EEG-61

**REVIEW OF THE WIPP DRAFT APPLICATION TO
SHOW COMPLIANCE WITH EPA TRANSURANIC
WASTE DISPOSAL STANDARDS**

Environmental Evaluation Group
New Mexico

March 1996

Figure 3
(From Reference 9)

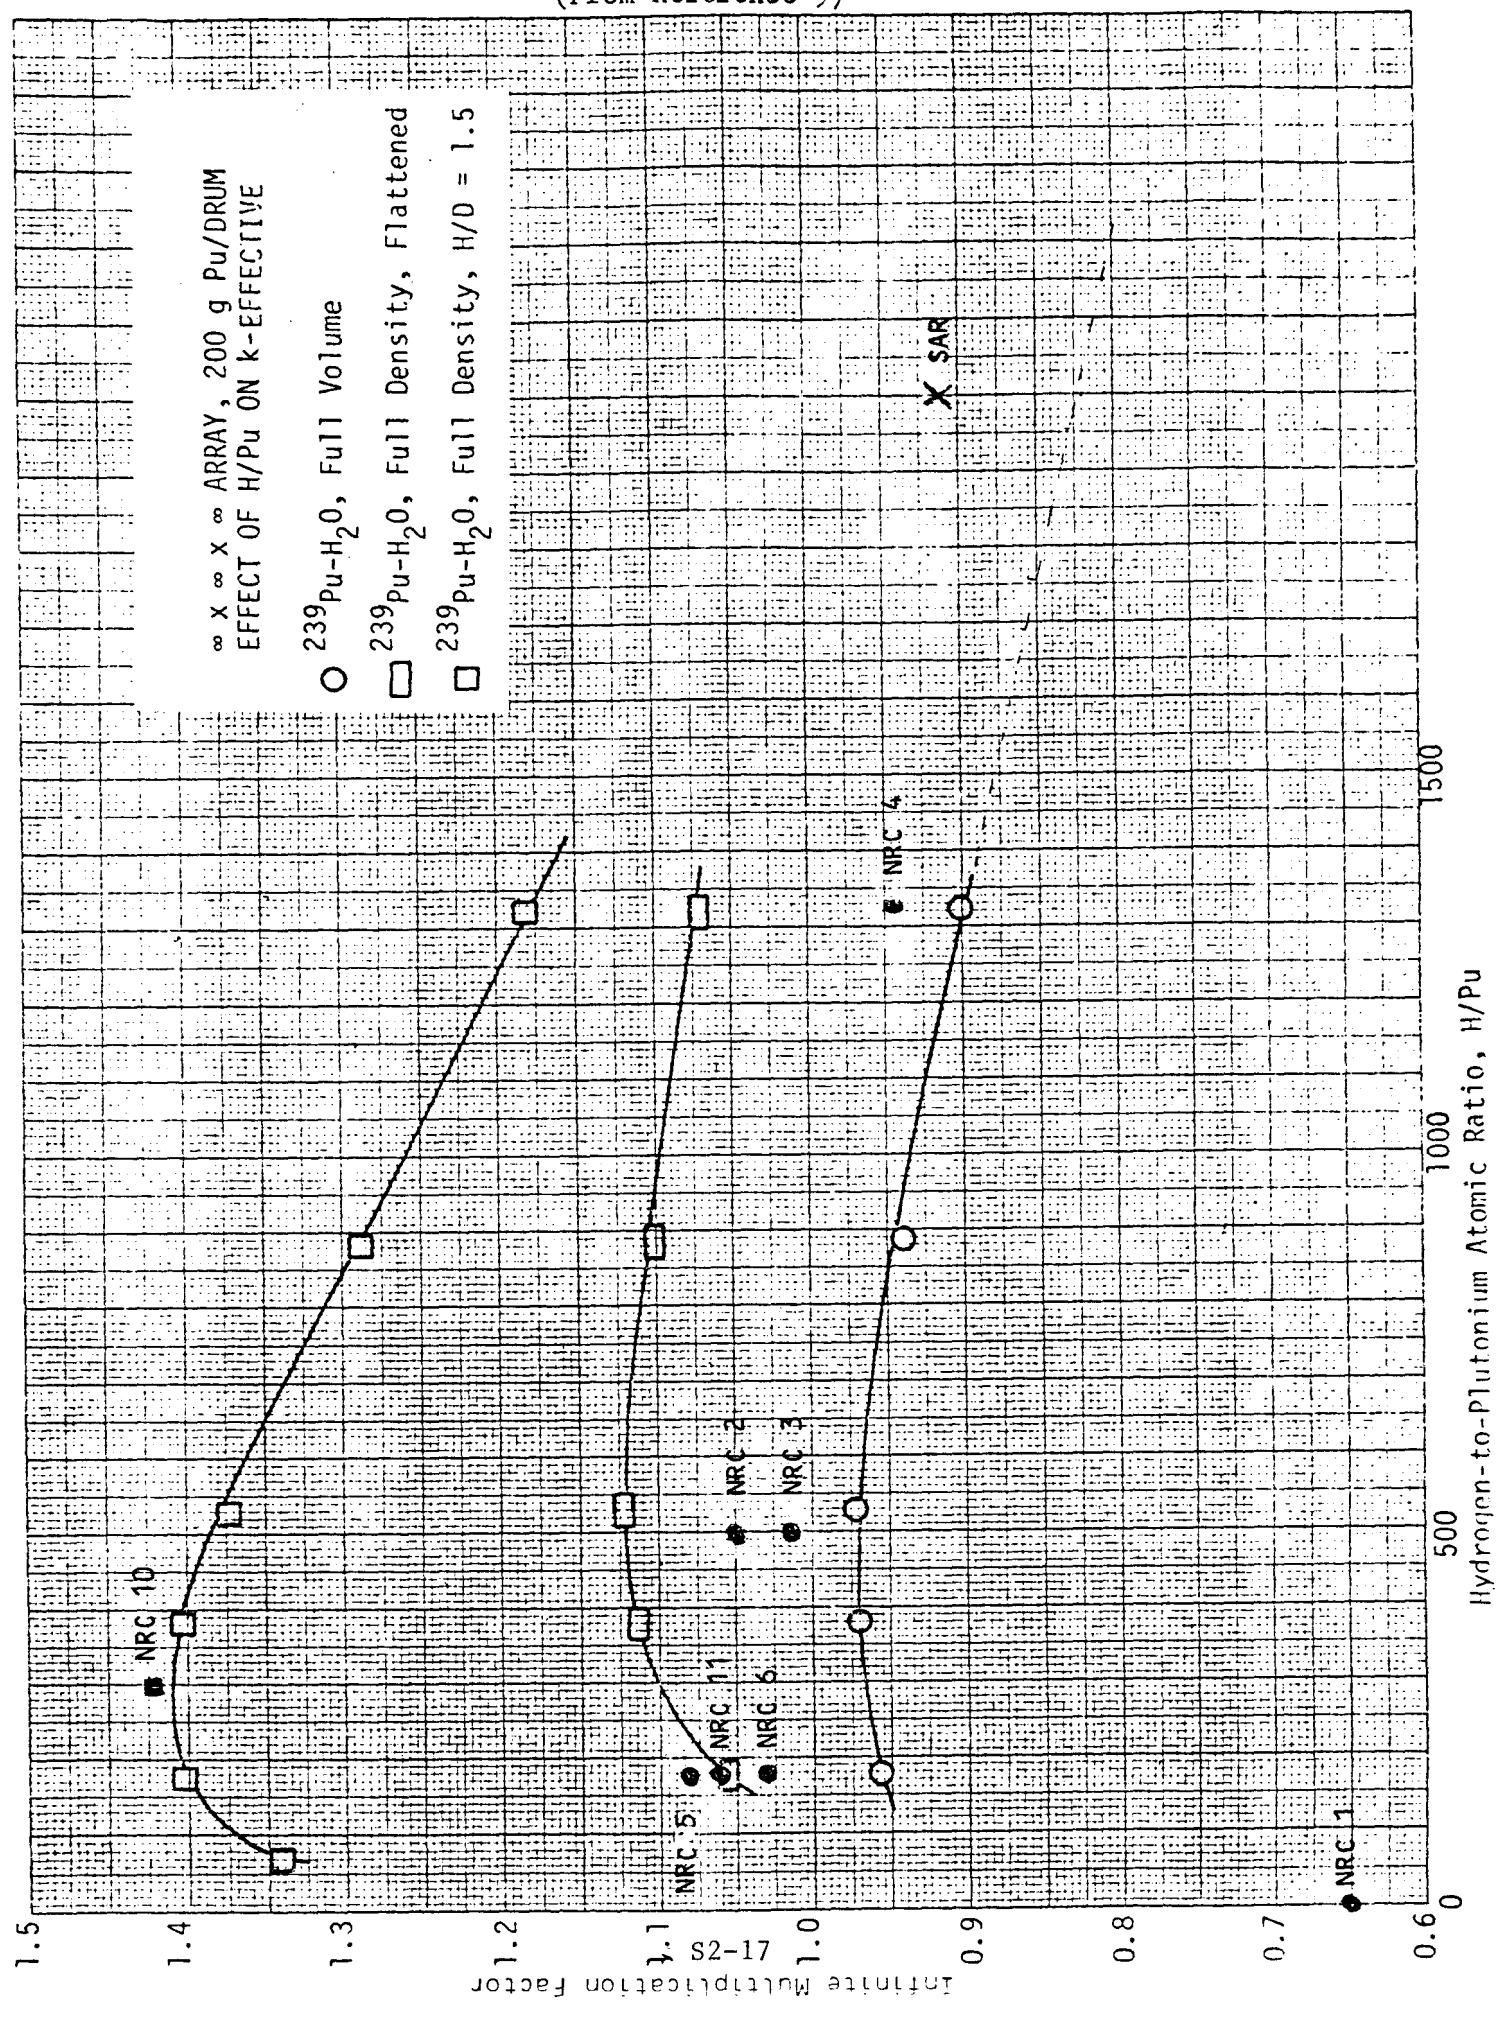
The calculations performed in Silver Spring, however, revealed some discrepancies which are not in the conservative direction (see Figure 3). Most of these calculations provided an independent check on the full volume infinite array analysis of Rockwell Hanford Operations. Eliminating the results which are not comparable on the basis of iron densities (Nos. 2 and 5 in Fig. 3) or cross section structure (No. 11 in Fig. 3), the multiplication factors calculated in Silver Spring are higher than those of Rockwell Hanford Operations by approximately +0.01 to +0.08. The single result for the full density array implies that the discrepancy is significant only for the full volume cases.
